MEMORANDUM

SUBJECT: Mandatory Referral No. 08401-MCPS-1: Carderock Springs Elementary School -
School Replacement Project, 7401 Persimmon Tree Lane, Bethesda, R-200 Zone,
Potomac Subregion Master Plan

Carderock Springs Elementary School Replacement Project 2008

Add-Alternate Plan

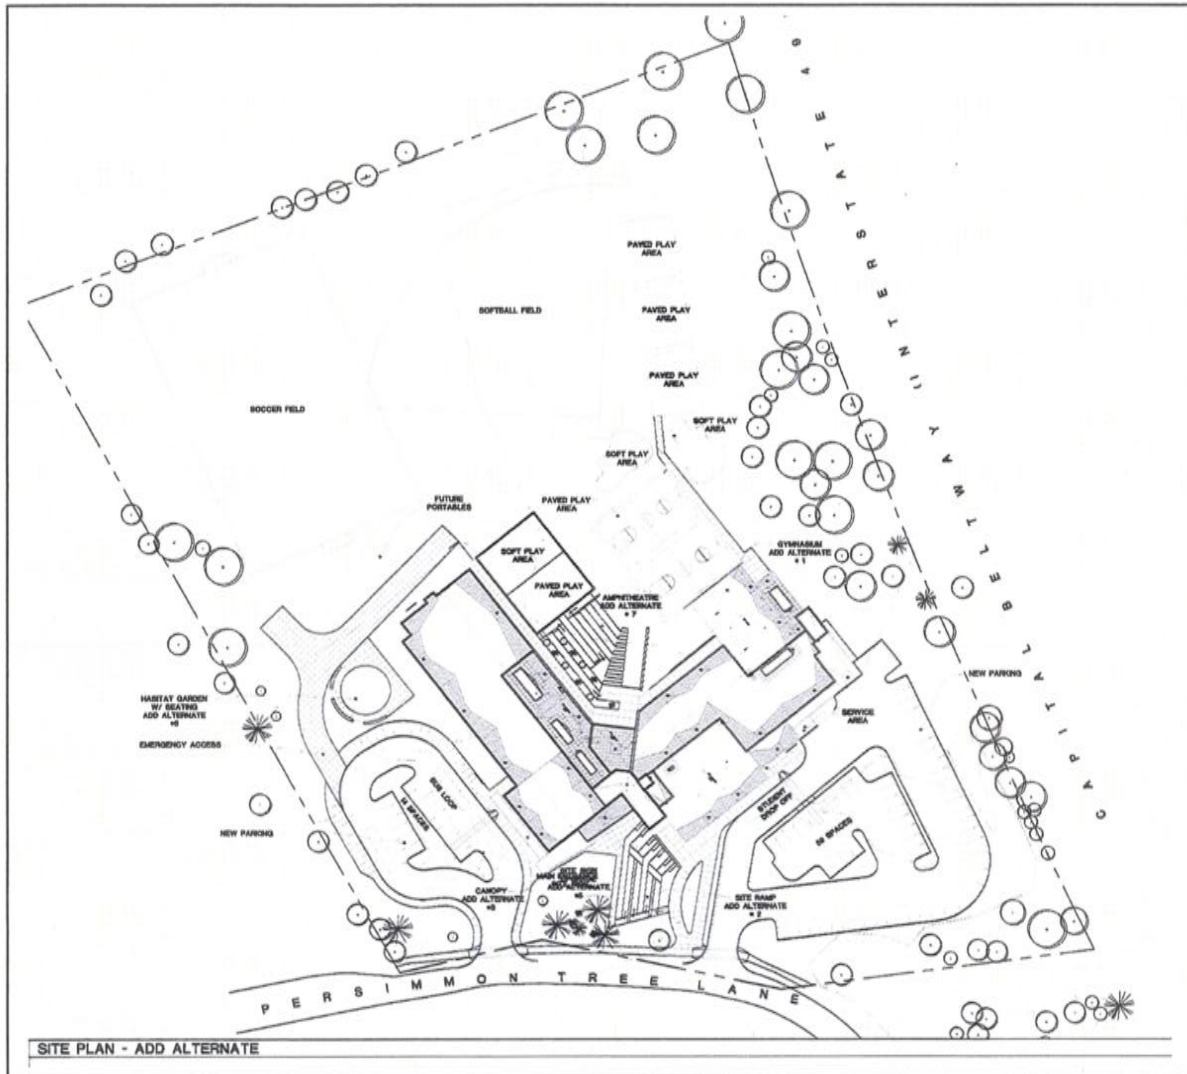
Planning staff strongly recommends the inclusion of the gymnasium despite cost considerations because the gym will provide:

The building design proposes the use of geothermal heating and cooling. The applicant proposes to eliminate this type of mechanical system if future costs exceed current estimates. Planning staff strongly recommend the incorporation of the geothermal system to achieve the highest level of efficiency with respect to energy use and building longevity.

Tree Canopy Plan

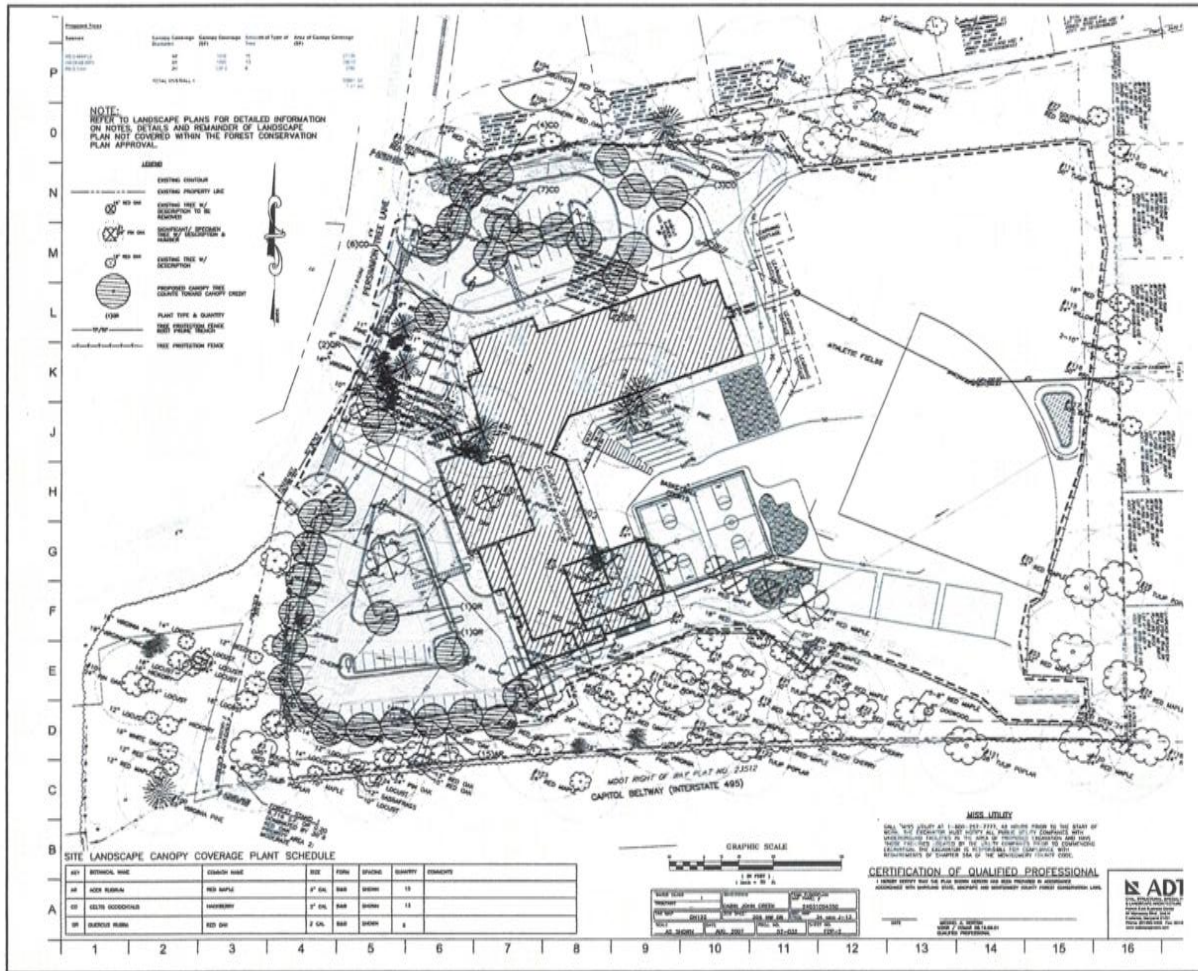
The submitted Landscape Plan proposes tree save throughout the site; the Landscape Plan should be revised to provide the following additional plantings:

- a. Fourteen shade trees to be planted next to the roadway pavement along the Persimmon Tree Lane street frontage, extending to Comanche Court to enhance pedestrian safety (reducing vehicular-pedestrian conflicts);
- b. Three additional shade trees to be planted within the south parking area islands;
- c. Replace ornamental trees at the main entrance and within the south parking area with shade trees to reduce pavement temperatures and heat island effects;
- d. Provide two clusters of three shade trees near the three paved play areas;
- e. Provide five additional shade trees along the east property line adjacent to the Stone Trail Drive residential lots;
- f. Shade trees should be a large leaf species such a red oak, and a size of 2.5-3.0 inch caliper at the time of planting.
